ph.9397 6222 rs@rodgersmitharchitect.com.au **WD 13.11.5A**

WD 13.11.6A

ph.9397 6222 rs@rodgersmitharchitect.com.au **WD 13.11.7A**

Section A.

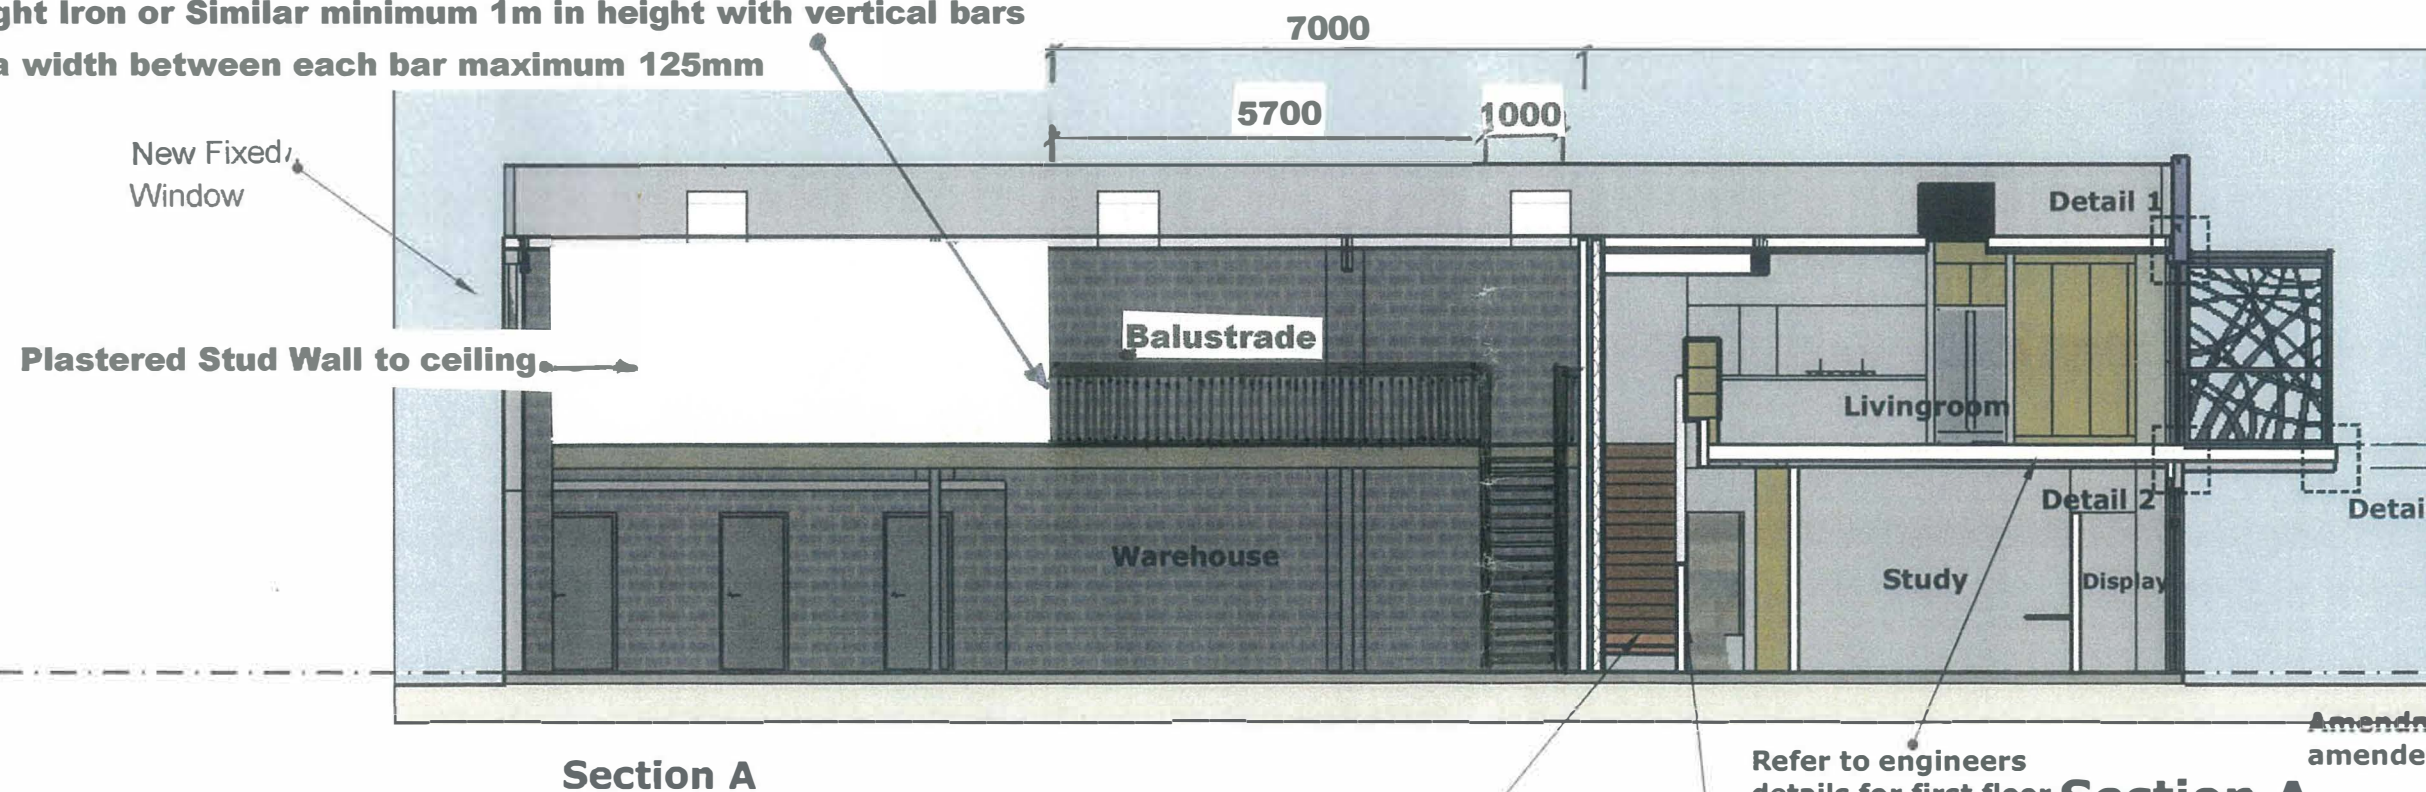
Amendment A 6.2.15 Stair and balustrade notes amended. Balcony framing and level changed.

Selected timber stair with 240 x 45 KDHW stringers and ex 290 x 30 treads (270 goings with 20 nosing overhangs). Fix 50 diam. KDHW handrails with stainless steel brackets 900 above stair.

Solid plasterboard balustrade to stair min 900 above nosings.

Detail 6
Fire rated wall to roof detail, perpendicular to purlins.

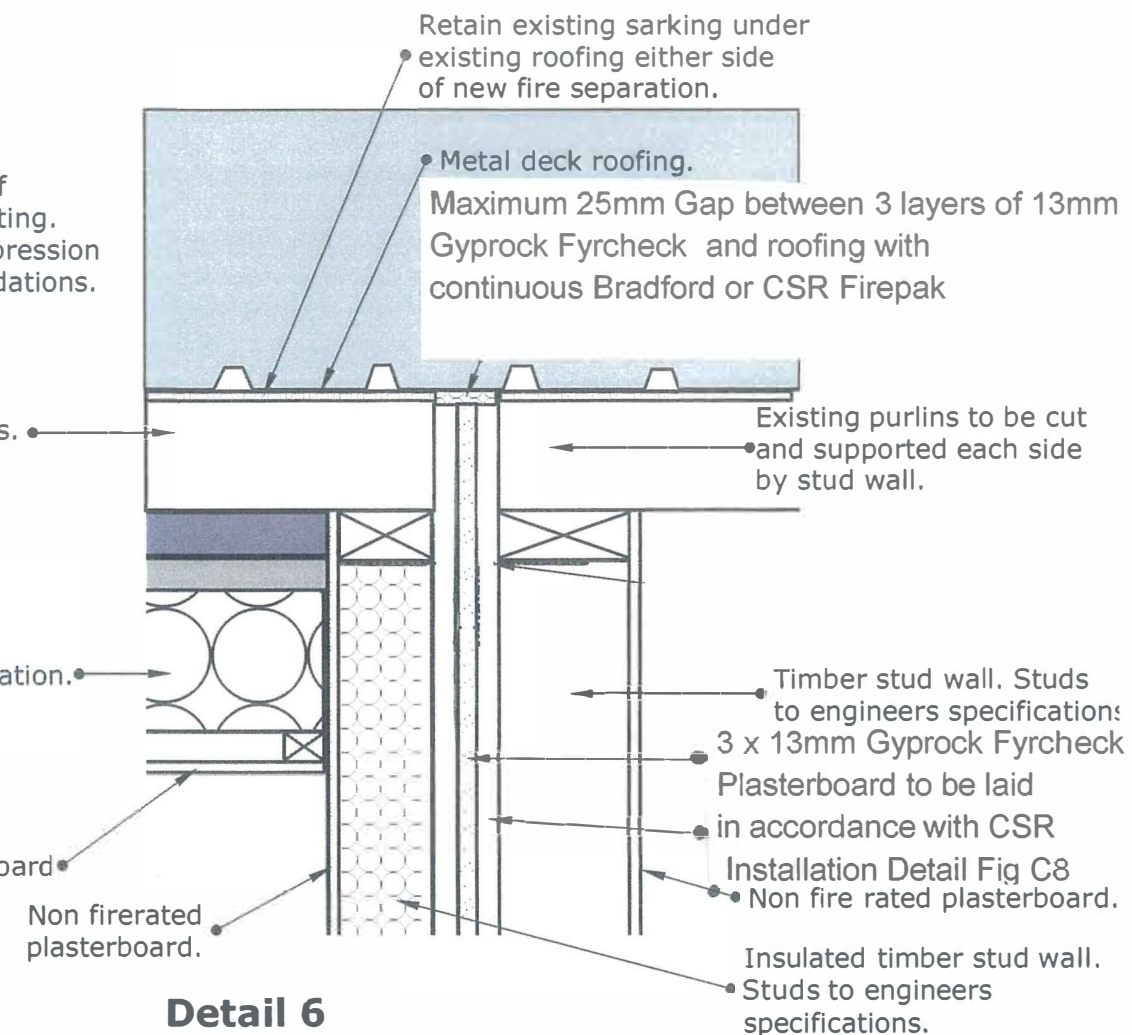
Amendment A 6.2.15 Fire rated wall type amended. Detail 6.

Detail 8 Fire rated wall to roof detail, parallel to purlins.

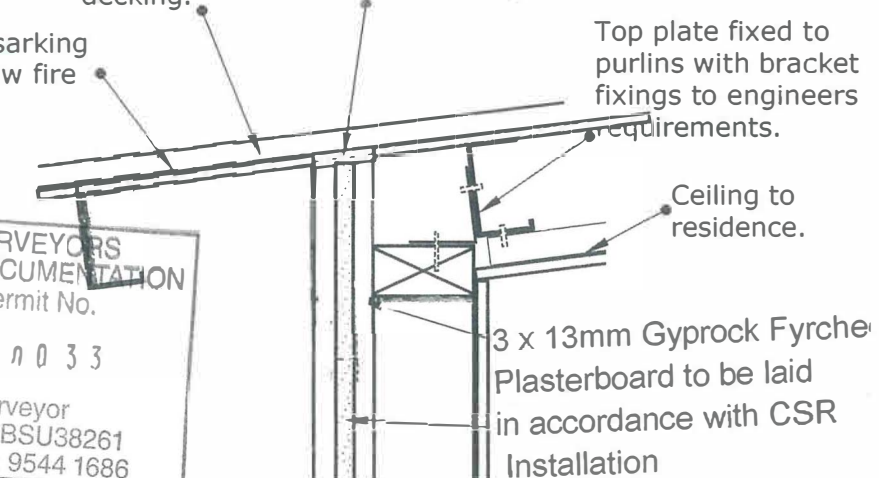
Amendment A 6.2.15 Stair and balustrade note removed. Wall details Detail 8.

Maximum 25mm Gap between 3 layers of 13mm Gyprock Fyrcheck and roofing with continuous Bradford or CSR Firepal

Retain existing sarking either side of new fire separation.

Elevations

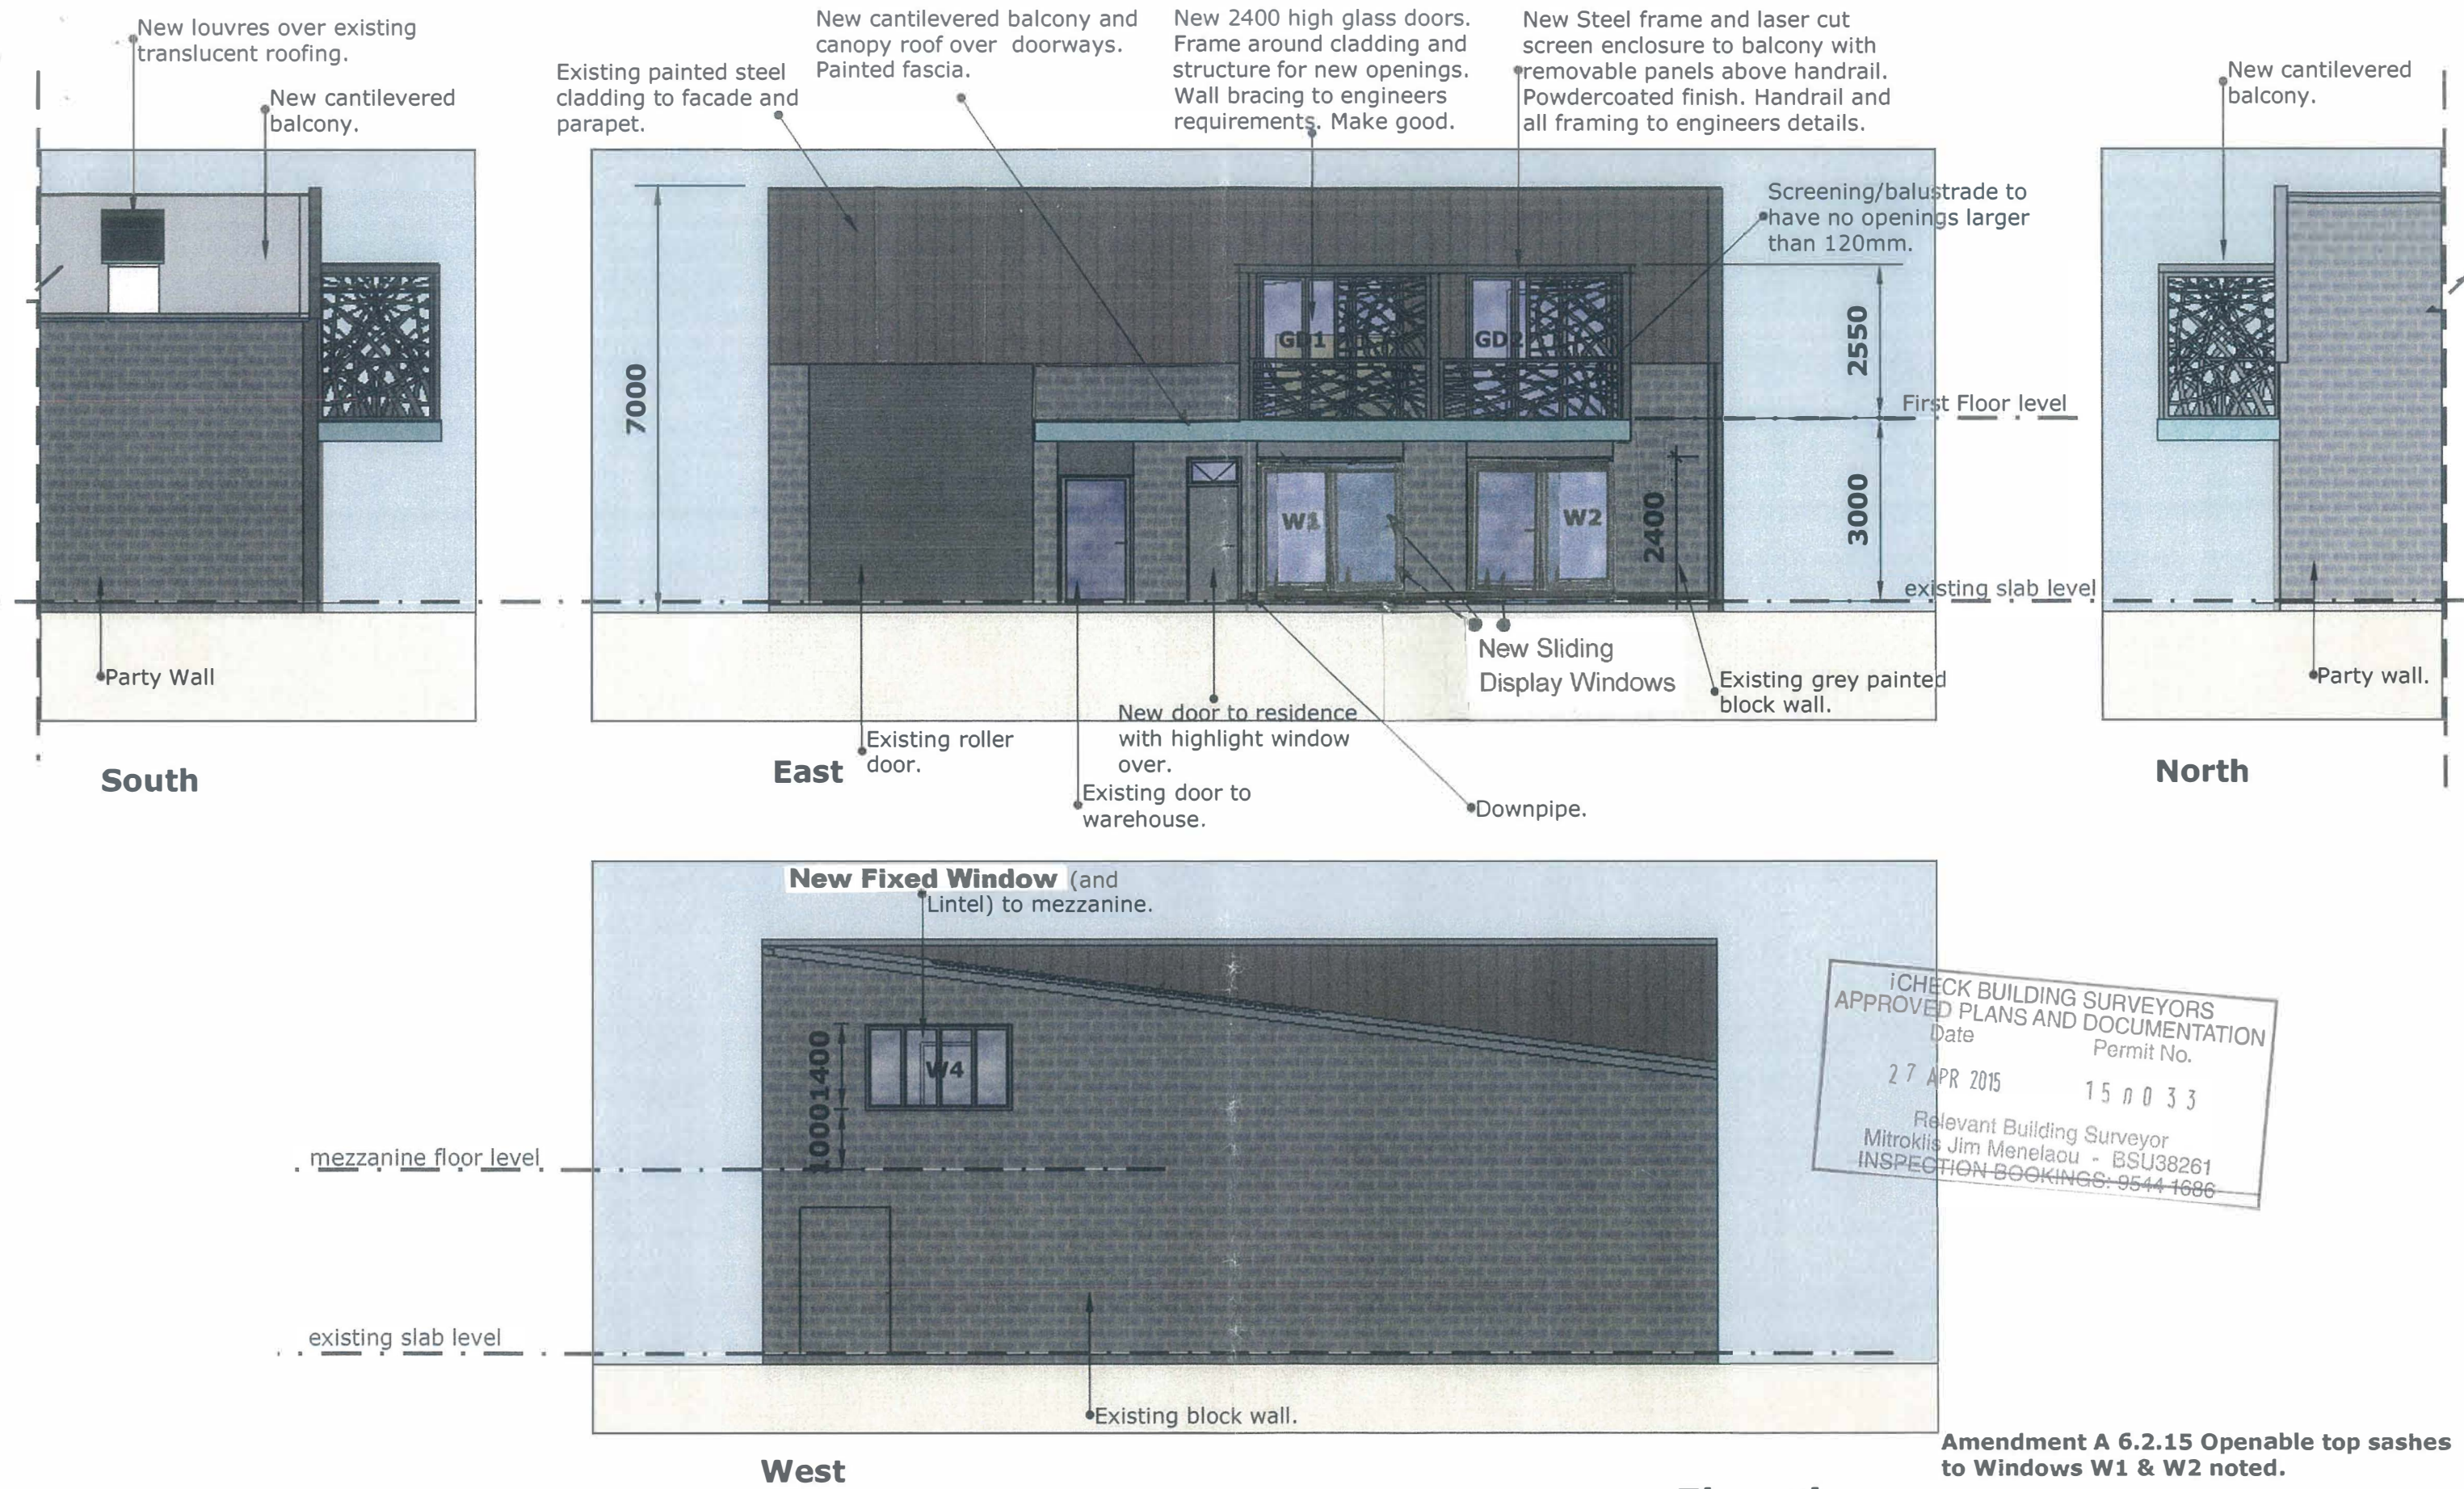
Amendment A 6.2.15 Openable top sashes to Windows W1 & W2 noted.
